FOIA/PA NO: 2014-0071

SUBJECT: DIFFERING PROFESSIONAL OPINION INVOLVING
DIABLO CANYON SEISMIC ISSUES
(DPO-2013-002)

Figure 1. Increased Predicted Ground Motions from Near Plant Earthquake Faults

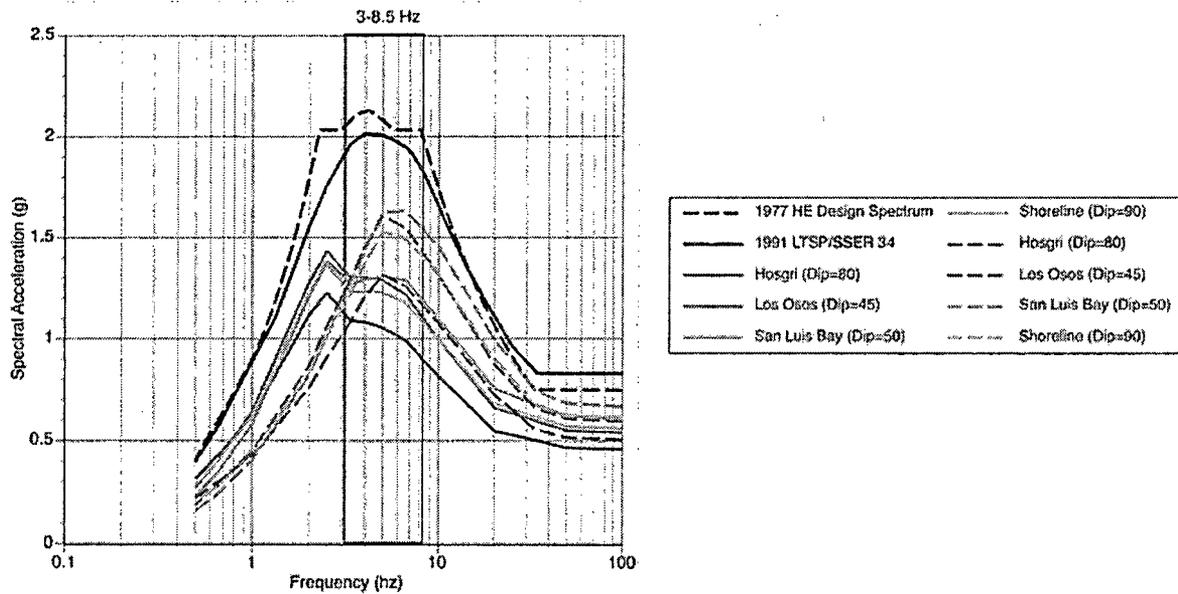
Diablo Canyon SSCs may not be able to perform their specified safety functions following a Safe Shutdown Earthquake. Figure 1 shows the increase in predicted ground motions at the site from an reevaluation of three near plant earthquake faults. New seismic studies established that ground motions from the Los Osos, San Luis Bay, and Shoreline Faults now exceed the ground motions of the Safe Shutdown Earthquake (not shown on the graph). Table 1 compares the peak ground acceleration from each fault (at 5% damping)¹ with the OBE and SSE peak ground motions (0.2 g and 0.4 g).² PG&E has not evaluated the increase in seismic ground motion against the SSC qualification basis for the OBE and SSE. The previous NRC replacement reactor head inspection concluded very little seismic margin exists for some RCS pressure boundary ASME Section III Boiler and Pressure Vessel Code limits.³ The increases in OBE and SSE seismic loading from the new information would likely result, if evaluated, in ASME Code allowable limits being exceeded; rendering some RCS pressure boundary components inoperable.

Figure 2. Horizontal Design Response Spectra – Scaled to 1g Horizontal Ground Acceleration

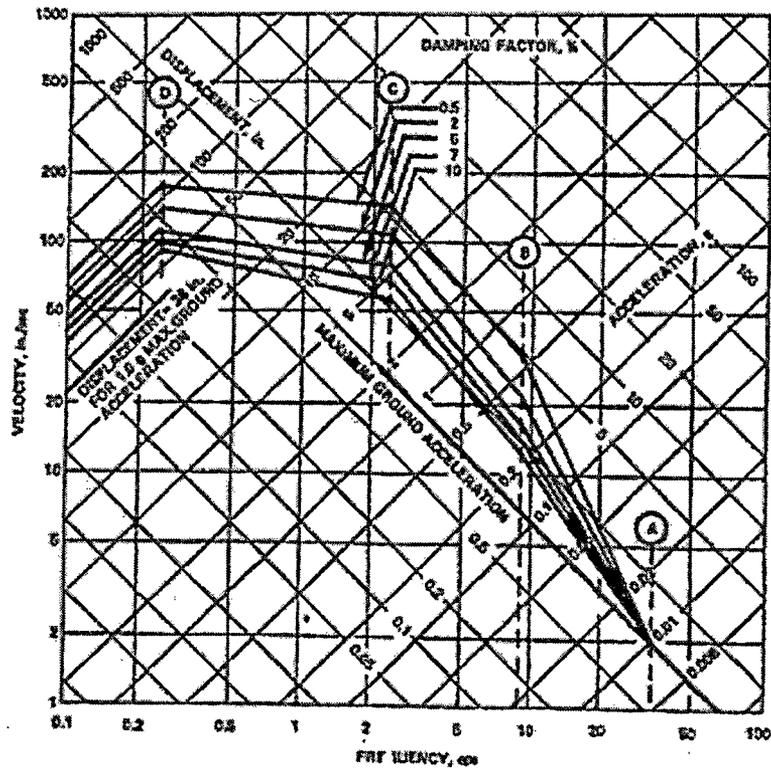
Figure 2 illustrates the affect that damping has on component amplification and displacement velocity for an earthquake normalized with a 1.0 g peak horizontal ground acceleration (Point A).¹⁴ For the natural frequency range for most seismically qualified SSC (3.3 – 8 Hz, between Points B & C), velocity and acceleration can vary greatly with damping. For example, the figure shows that a component with a natural frequency of 3.3 Hz, using a damping value of 0.5% results in a velocity of approximately 125 in/sec, while using a damping value of 10% results in a velocity of only about 55 in/sec. Figure 3 illustrates how changes in assumed damping directly affect acceleration at the auxiliary building floor for the Hosgri Event. The figure shows that applying a larger damping value results in a much lower acceleration.

Figure 4
HE Maximum CRDM Bending Moments

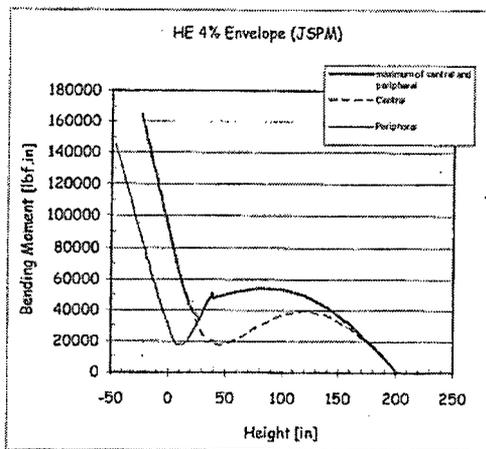
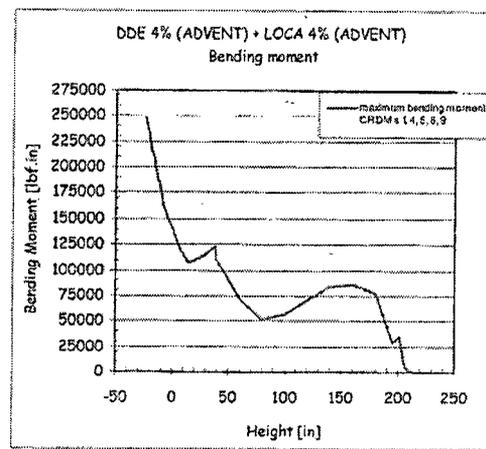
Seismic qualification of the primary RCS pressure boundary was limited by all three design basis earthquakes. For some SSC, the HE was more limiting, for others, the SSE or OBE was more limiting for seismic qualification. For example, the inspectors identified that the OBE and SSE were more limiting for some RCS pressure boundary components during the Unit 2 replacement reactor head inspection. The replacement head designer used inappropriately high seismic damping values when demonstrating that RCS pressure boundary met Section III of the ASME Boiler and Pressure Vessel Code. For corrective action, the designer recalculated RCS component stress using the current licensing basis (CLB) damping values and discovered that some reactor head components exceeded Code allowable values for the OBE.¹⁸ The designer again recalculated Code allowable stress using the higher damping values provided in RG 1.61, "Damping Values for Seismic Design of Nuclear Power Plants," Revision 1. The second recalculation also resulting in component stress levels exceeding Code allowable. The design subsequently demonstrated Code acceptance criteria by substituting the time history method with response spectrum method. Incorporating the higher RG 1.61 damp values into the CLB required a licensee amendment. The end result did not provide for much margin to accommodate an increase in the design basis earthquake. The recalculation concluded that the SSE was more limiting.¹⁹ For example, as shown in Figures 4 and 5, the control rod drive mechanism pressure housing assembly (CRDM) bending moments were more limiting for the SSE than the HE.

The recalculation also identified that SSE loads were more limiting than the HE for the control rod drive mechanism pressure housing assembly and the external loads for the vessel head closure weld shear forces (6,332 lbs for the SSE compared to 4,431 lbs for the HE). Also, both the OBE and SSE inner and outer diameter shear forces were more limiting than the HE (OBE was 9,764 lbs, SSE was 6,567 lbs, while the HE was only 4,432 lbs).²⁰
